Addendum 150 – UN Regulation No. 151

Amendment 1

Uniform provisions concerning the approval of motor vehicles with regard to the Blind Spot Information System for the Detection of Bicycles

Appendix 1, Figure 1, amend to read:

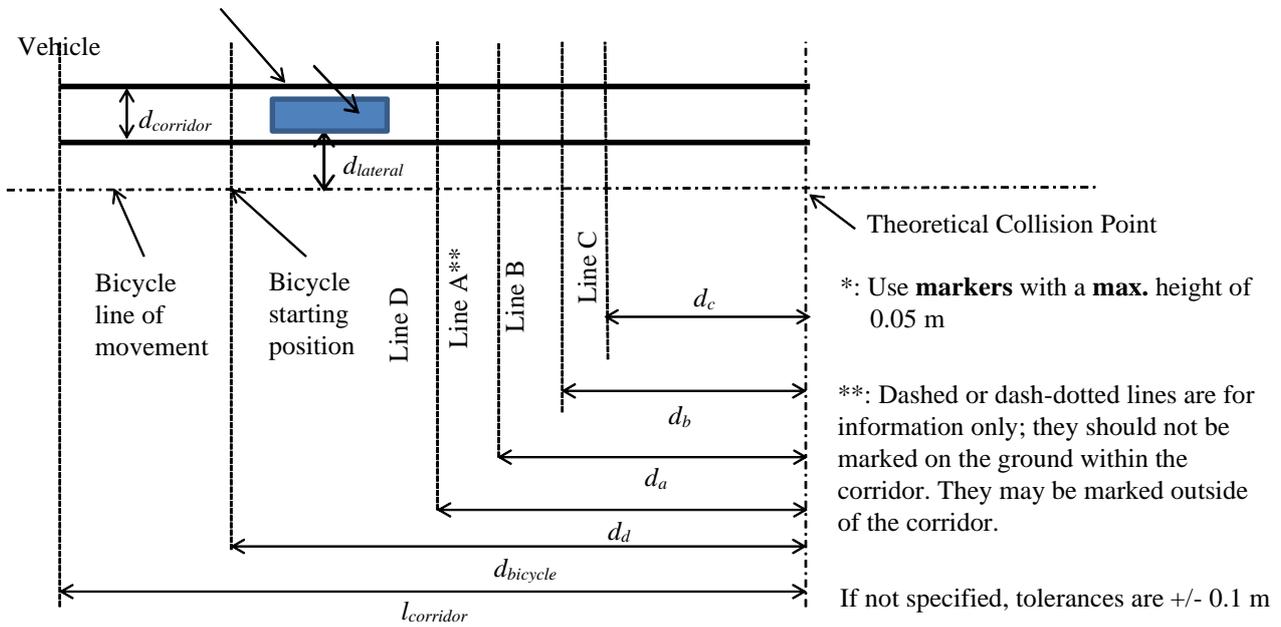
Mark corridor using markers *, spacing not more than 5 m
